MRW Project: S12076

**Re: Structural Condition Inspection
Algo Centre Mall, Elliot Lake, ON**

**Re: Parking Deck Waterproofing Repairs
Algo Centre Mall, Parking Deck**

**Re: Structural Review the Parking Deck Structure at
Algo Centre Mall, Elliot Lake**

Picture 5: Impact at SW corner of Algo Inn at expansion joint.

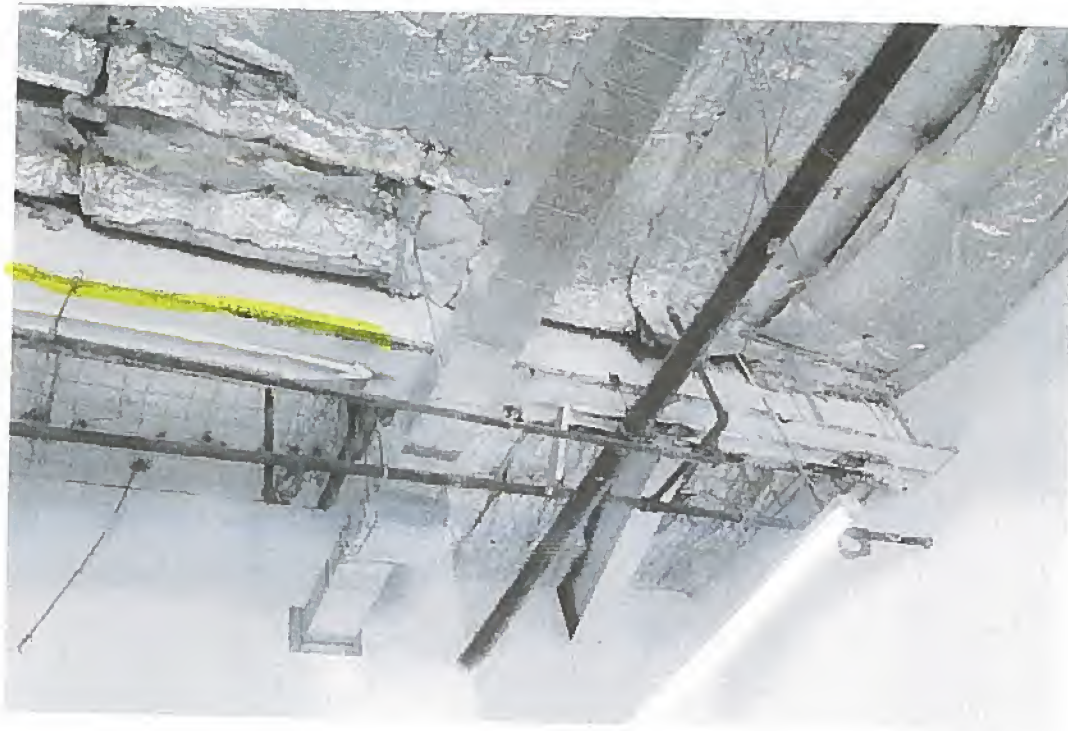
All beams inspected had little loss of section and we would consider the members still structurally sound. The ongoing leakage from the parking deck is of particular concern in the areas of Zellers, and the expansion joint located along the south wall of the Algo Inn, over the municipal library. As per Pictures 5 and 6 we noted vehicular impact on wall siding in this area, that may also have added to the problem.

Picture 7: Rusting on steel beams in receiving of Zellers.

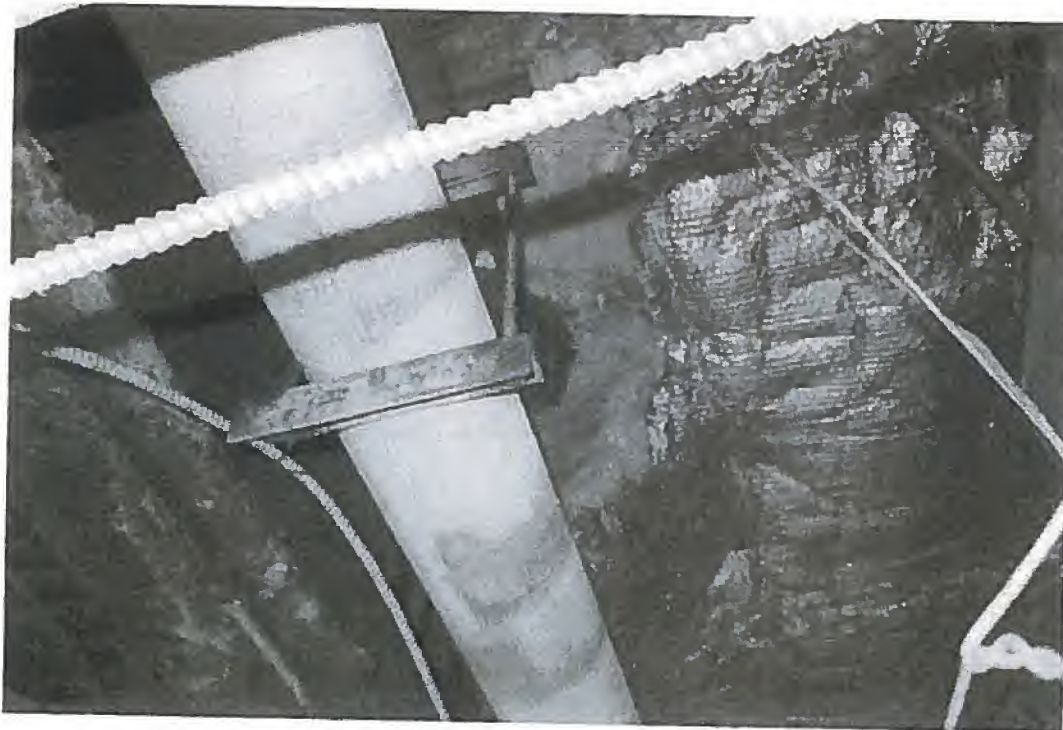
Our inspection revealed evidence of rusting on the structural steel beam members in areas where the parking deck has leaked as shown in Pictures 1 through 8. The area of open walkways shown in Pictures 9 through 12 also have areas with surface rust.

Picture 3: Line 5 in Zellers below water ponding in Picture 2. Top shelf brown storage bin right of column collects water, half full at time of inspection.

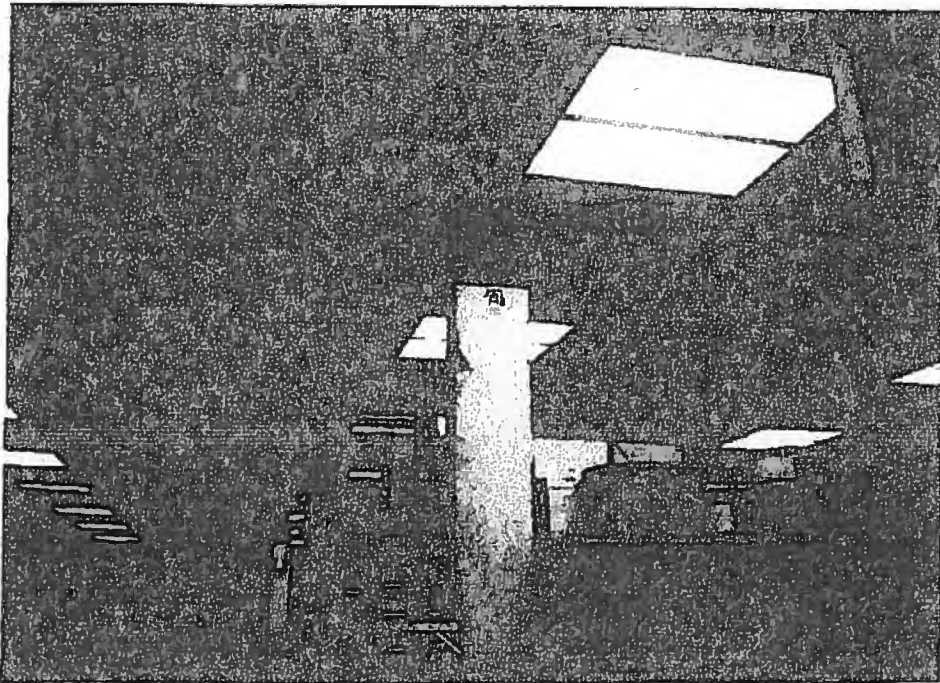
There are several leakage areas, within the Zellers Store predominately at grid lines. Our inspection revealed that grid line 5 was the most severe. At this location elaborate collection systems have been installed above the suspended ceiling to collect water infiltration through the roof structure. Picture 1 and 2 illustrate that water ponds on the parking area above this grid line beam and this appears to further aggravating the condition. It appears that the positive camber in the prestressed slabs is greater than the slope provided in structural steel frame, and thus water cannot flow to the drains on grid line 4.

The structural steel is not fire-rated throughout Zellers. The primer painted structural steel has surface rusting, but in all areas inspected no loss of steel section was observed.
